**Re: Minor Project Refinement No. 10 for the TL 6975 San Marcos to Escondido Project**

**ATTACHMENT A**  
**MPR-10 Form**

## TL6975 San Marcos to Escondido 69 kV Project CPUC Minor Project Refinement Form

**ATTACHMENT B**  
**MPR-10 Figure**

**TL6975 SAN MARCOS  
to ESCONDIDO PROJECT**  
MPR-10 Figure 1  
Structure Location 54  
San Diego County, CA

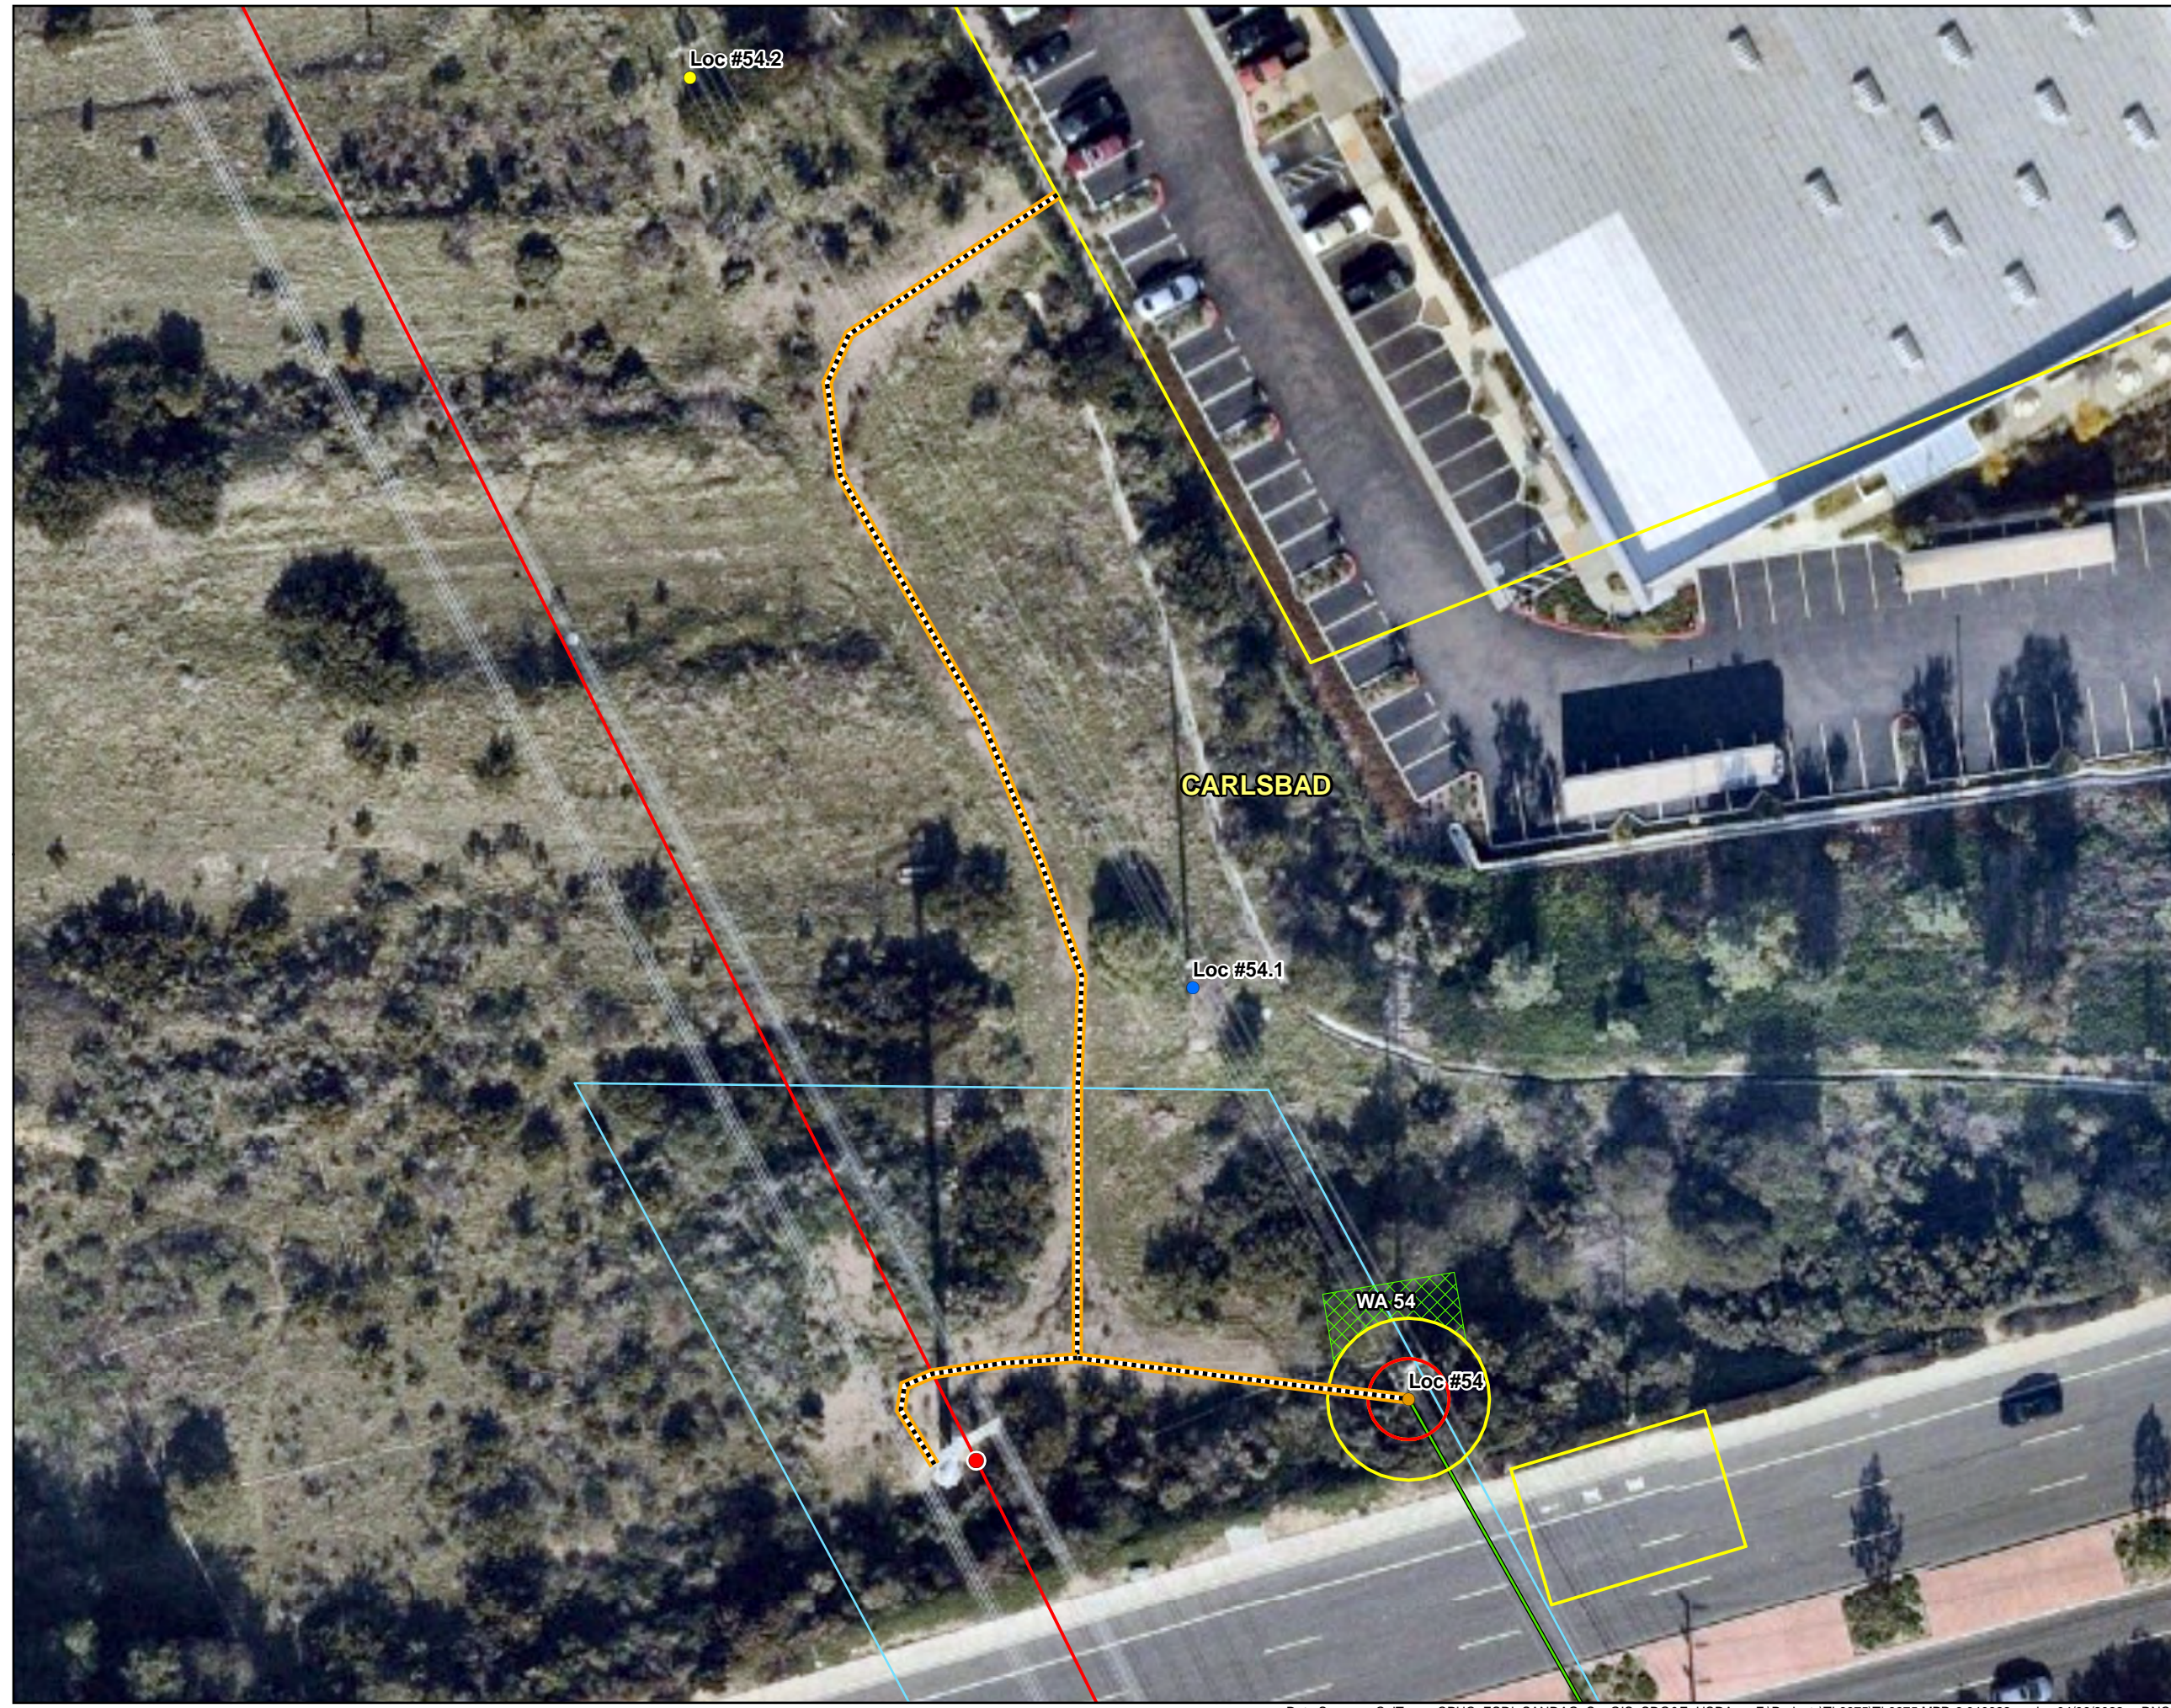
- **Location 54 Additional Work Area (WA 54):** WA 54 is located north of Location 54. The additional work area will be used for staging of equipment during foundation and pole installation activities, as well as the installation of conductor. The existing access road to WA 54 was not included in the Initial Study/Mitigated Negative Declaration (IS/MND) or NTP-1 Mapbooks and is therefore proposed for use herein as shown in **Attachment B, MPR-10 Figure**. A wood ramp will be positioned over the curb at the access road entrance in the business park to facilitate access for equipment and vehicles.

The existing pad and access road for the non-Project related existing pole west of Location 54 will be used for additional Project vehicle parking and temporary staging during construction activities at Location 54. Vegetation trimming will be required within WA 54. In addition, Location 54.1 has been changed from No Work/Information Only (as shown in the NTP-1 Mapbook) to Pole Top Work Only in **Attachment B**, as overhead work will be required at that location during wire installation activities. The overhead work required at 54.1 can be performed from the existing access road using a bucket truck, therefore an additional work area at this location is not being proposed. No work is proposed at Location 54.2.

- **WA 54:** The existing work area at Location 54 does not allow for adequate space to perform construction activities at this location. The replacement direct-bury pole at Location 54 will be installed just north of the existing direct-bury pole in order to transfer the hardware and conductor from the existing pole to the replacement pole (See **Attachment C, MPR-10 Site Photographs**). Large equipment is not able to access the site from the south due to the steep slope, therefore WA 54 is needed to position equipment during pole and conductor installation activities. Since the new pole location cannot be accessed from Palomar Airport Road due to the steep slope and existing pole, the use of the existing access road to Location 54 is also critical to perform work at this location.

**TL6975 SAN MARCOS  
to ESCONDIDO PROJECT**  
**MPR-10 Figure 2**  
**Structure Location 51**  
**San Diego County, CA**

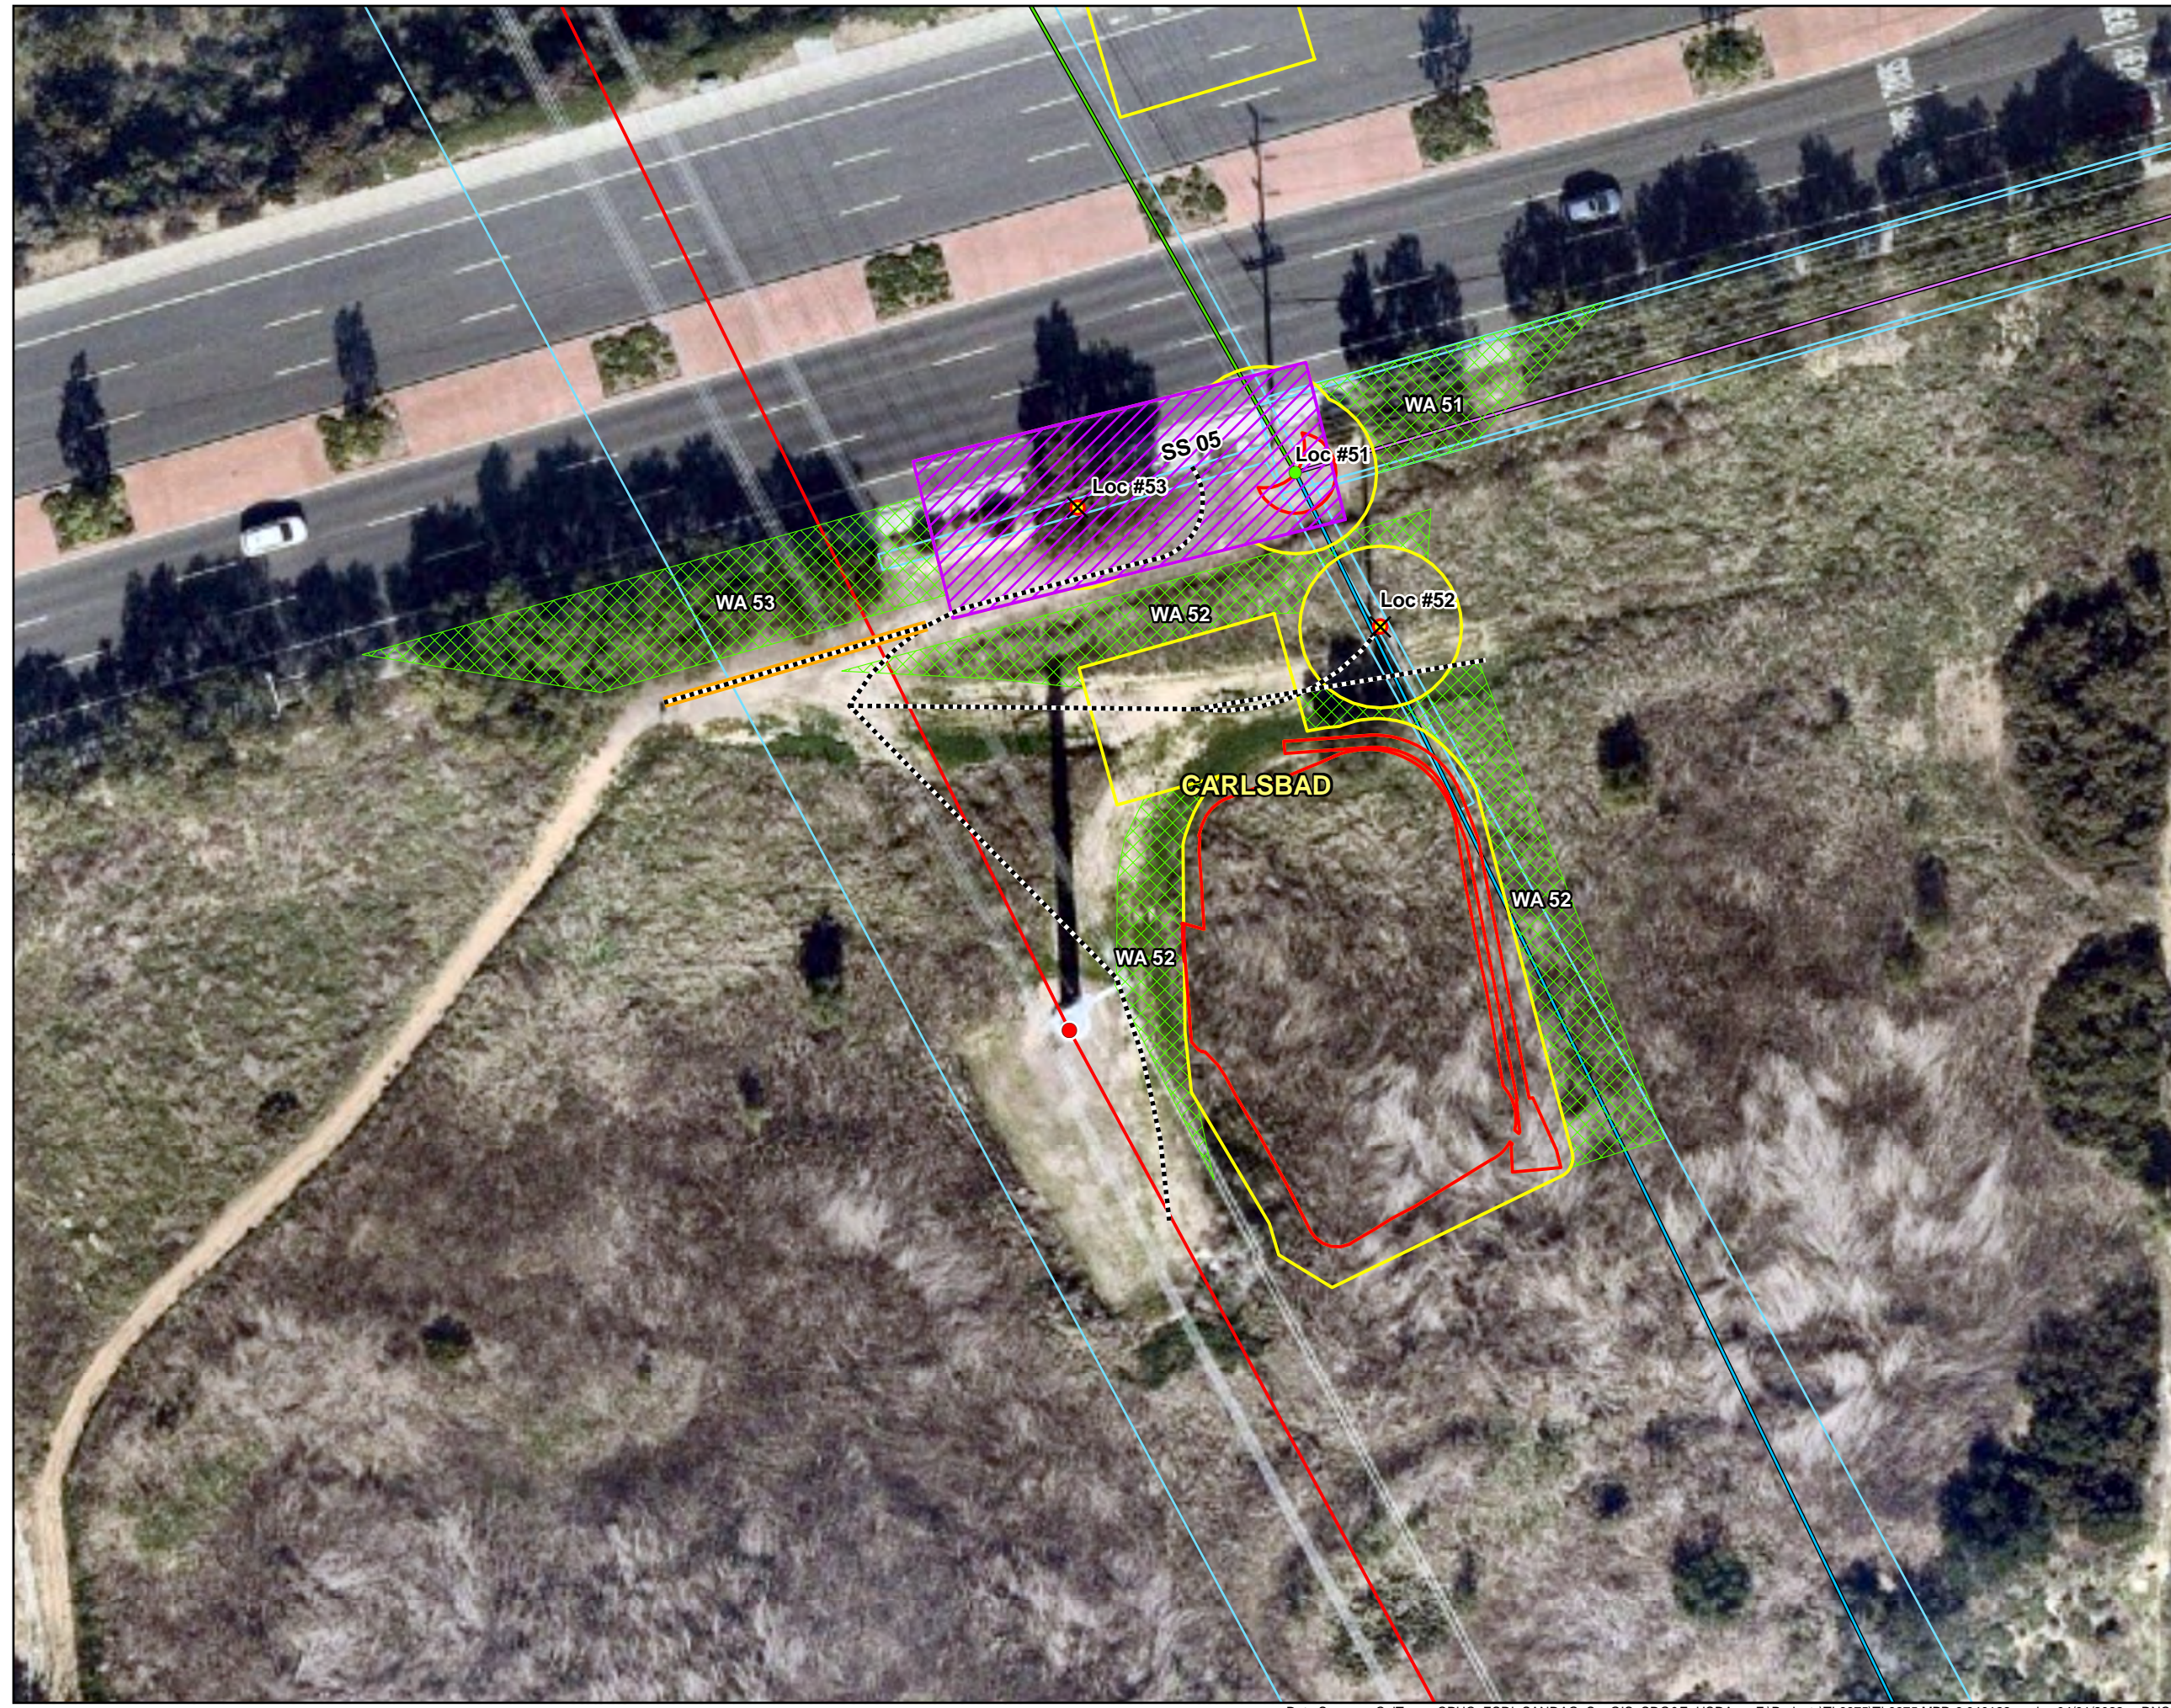
- **WA 51:** The existing work area for Location 51 does not allow for enough space to perform construction activities on the east side of Location 51 due to the size of the pole and the equipment required to install the pole. WA 51 will be required for siting vehicles and equipment on the east side of the pole during the installation of dead-ends (located on the east side of the pole). The work area will also allow for adequate space to set up a guard structure for wire installation over Palomar Airport Road.

- **WA 52:** There are three areas labeled WA 52 to facilitate the installation of the corner pole and stringing of conductor at Location 51. One area is the slope between the two access road segments northwest of Location 52. It will be required to allow adequate space for one side of the 24-foot wide outriggers of the crane, which will be situated within SS 05 during the installation of the pole at Location 51. The crane does not have enough space within the access road to extend the outriggers without utilizing WA 52.

The portion of WA 52 on the west side of the area labeled, "Permanent Work Area" and south of Location 52 will connect the existing access road to a work area during the stringing of conductor. The portion of WA 52 on the east side of the area labeled, "Permanent Work Area" will be required to position stringing equipment in line with Location 51 during the wire pull from Locations 51-58.

**Photograph 1:**  
View of Location 51 and the additional temporary work area in green (WA 51). The Peruvian pepper tree that will be removed within WA 51 is also shown. Facing: NE

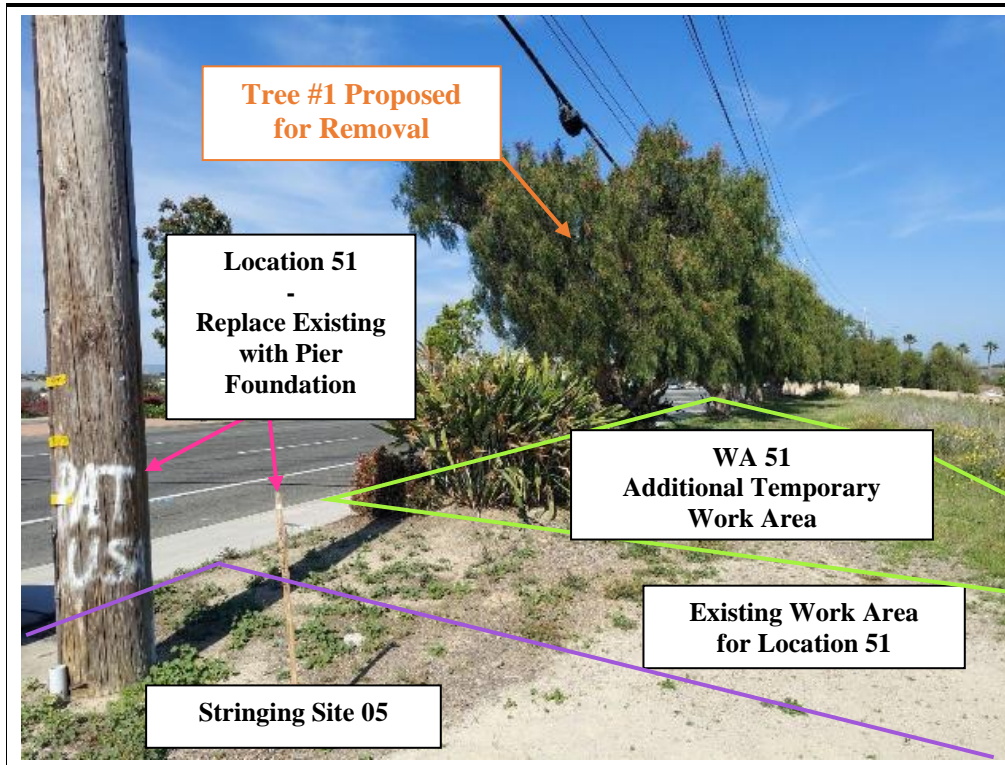
- **Location 51 Additional Work Area (WA 51):** WA 51 is located east of Location 51. WA 51 will be utilized for staging of materials and equipment during the installation of dead-ends on the pole at Location 51 and will allow for adequate space to set up a guard structure for wire installation over Palomar Airport Road. One Peruvian pepper tree is proposed for removal within WA 51 (See **Attachment C, MPR-10 Site Photographs**). Tree removal will take place using a chainsaw and skid steer.
